City of Minneapolis
Department of Community Planning and Economic Development
250 S. 4th Street, Room 300 PSC
Minneapolis, MN 55415-1385

MEMORANDUM

SUBJECT: Kraus Anderson - 501-523 9th St S, 502-518 9th St S, and 811 5th Ave S

Committee of the Whole - Project Description
Kraus Anderson Corporate Headquarters
Minneapolis, MN

SITE PLAN

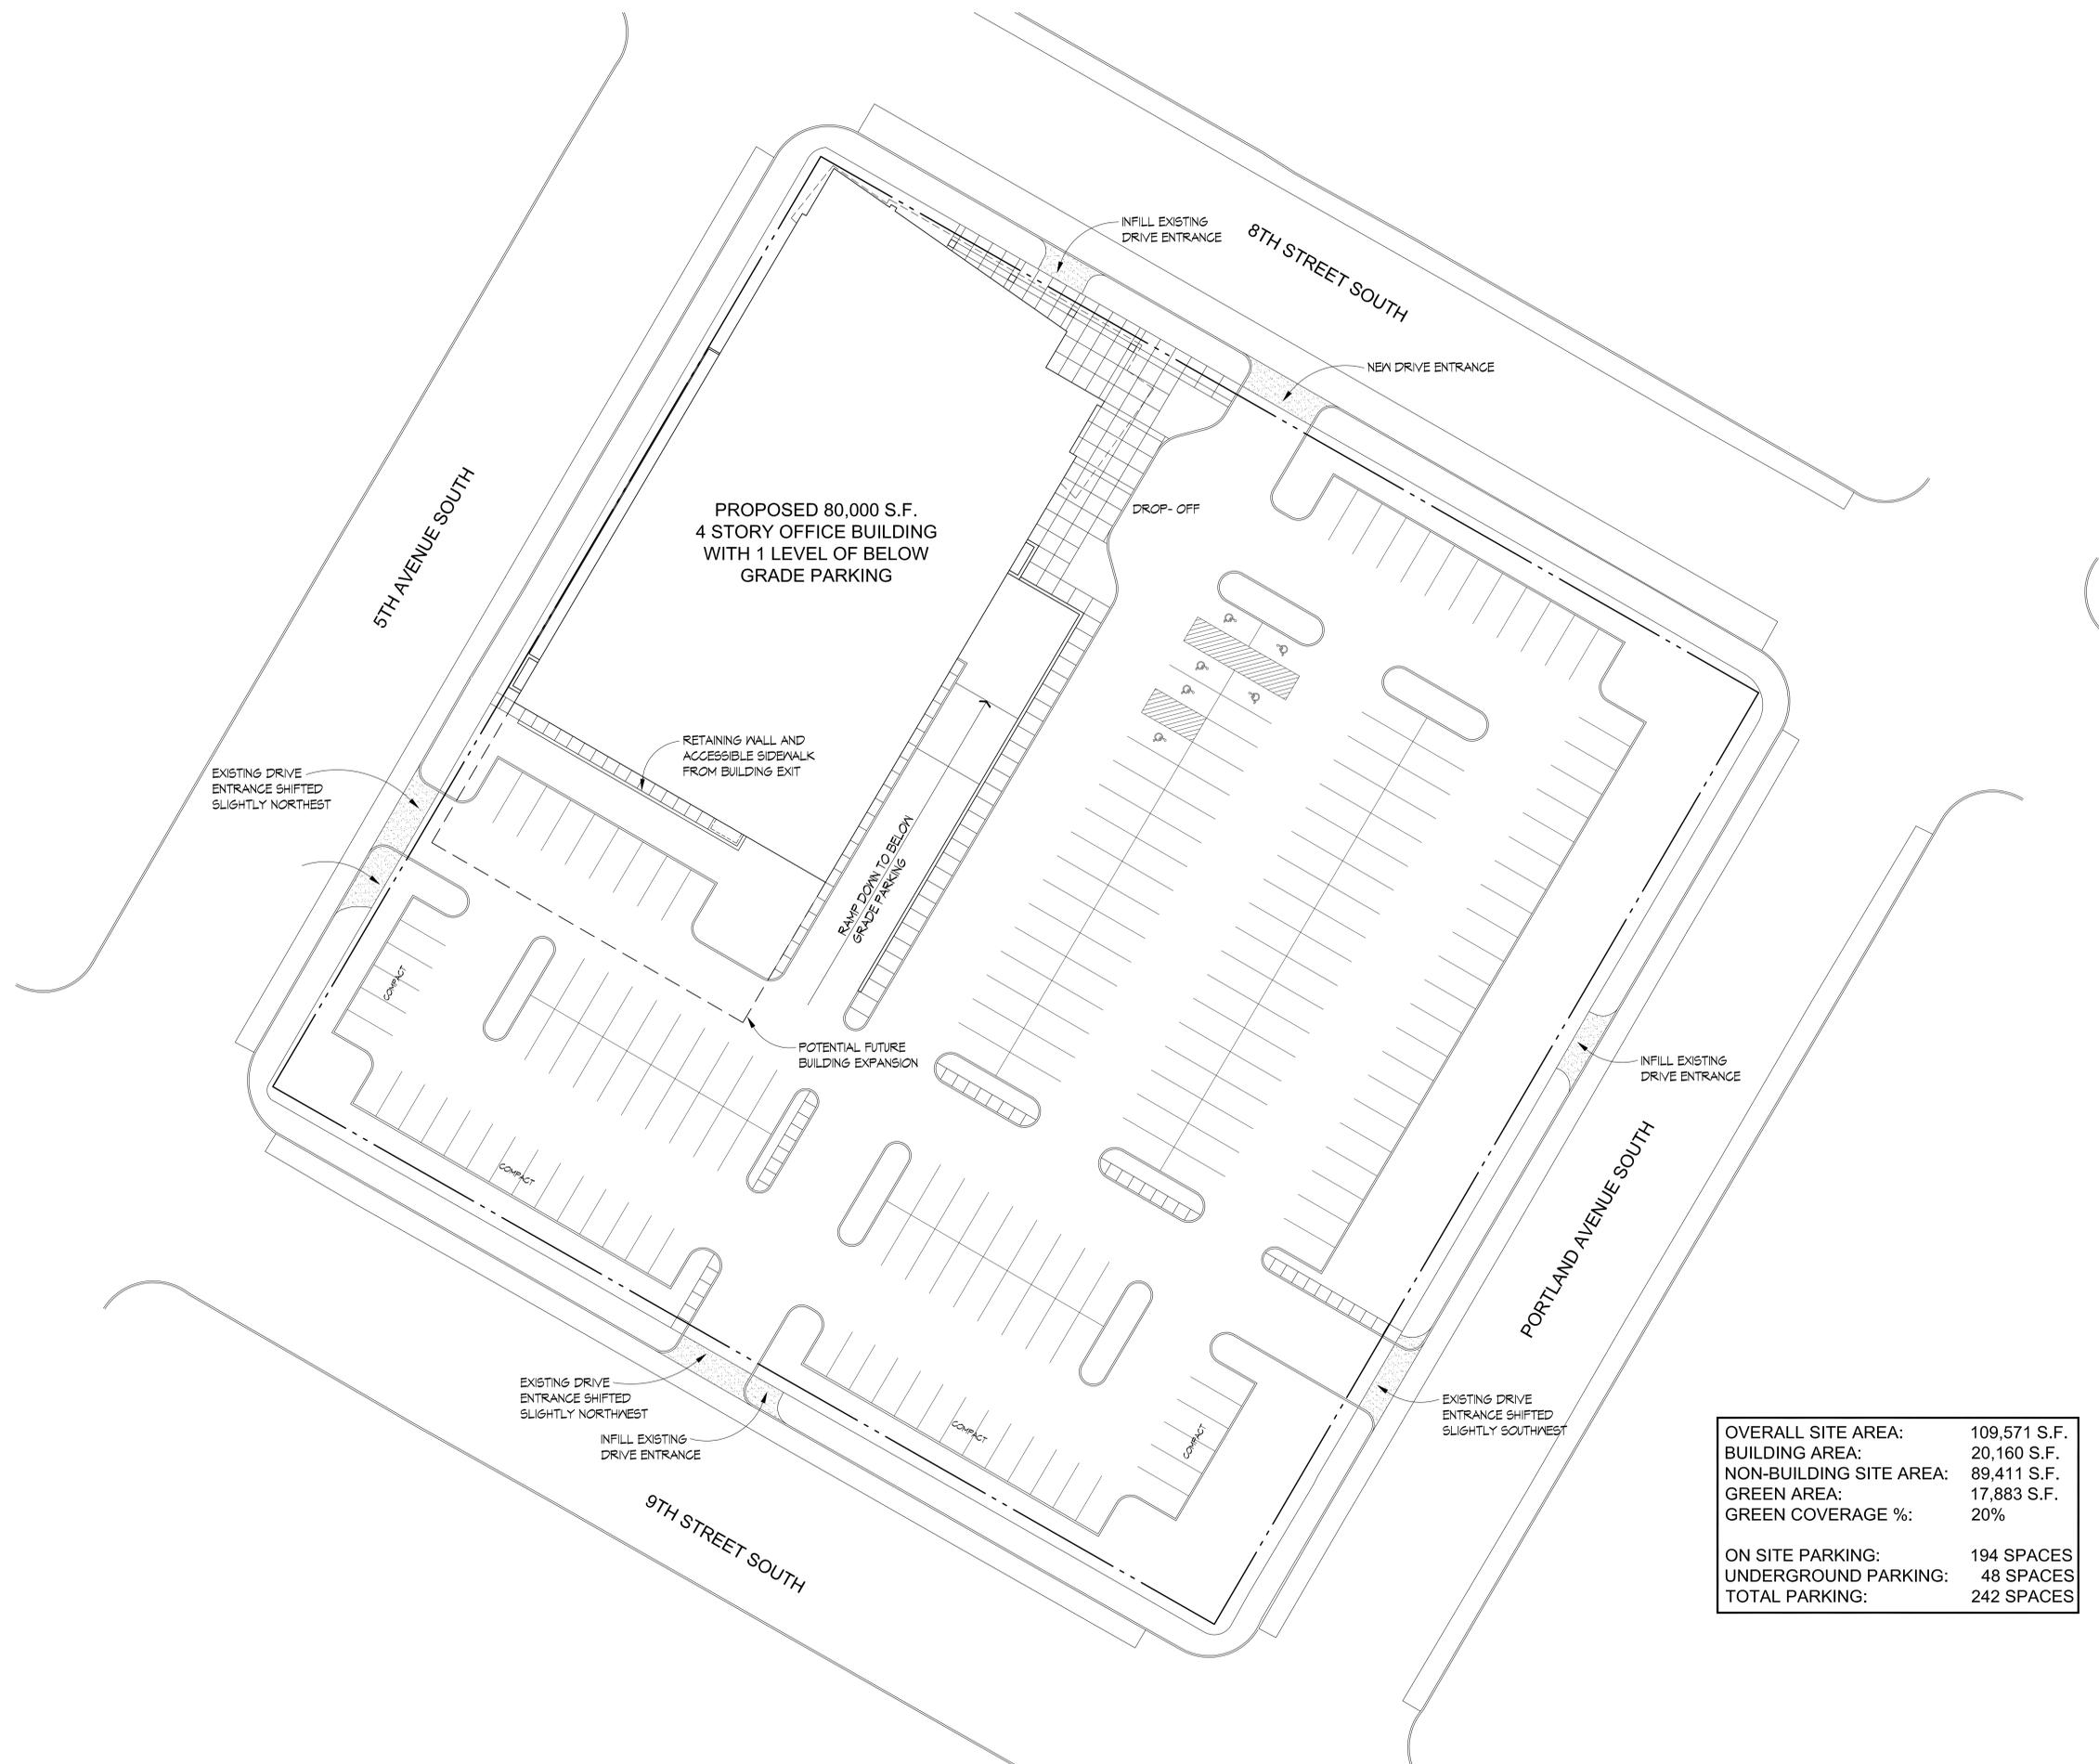
CPED Staff has concerns regarding the amount of surface parking proposed for the development as the supply encourages single-occupancy vehicular trips for nearly every employee that would work in the building. In addition, there is no guarantee for future phased development on the remainder of the parcel. The proposal results in the underdevelopment of the site as over 80% of the lot is covered by the proposed surface parking lot. As currently proposed, the parking lot would appear to meet the 20% landscaping requirement.
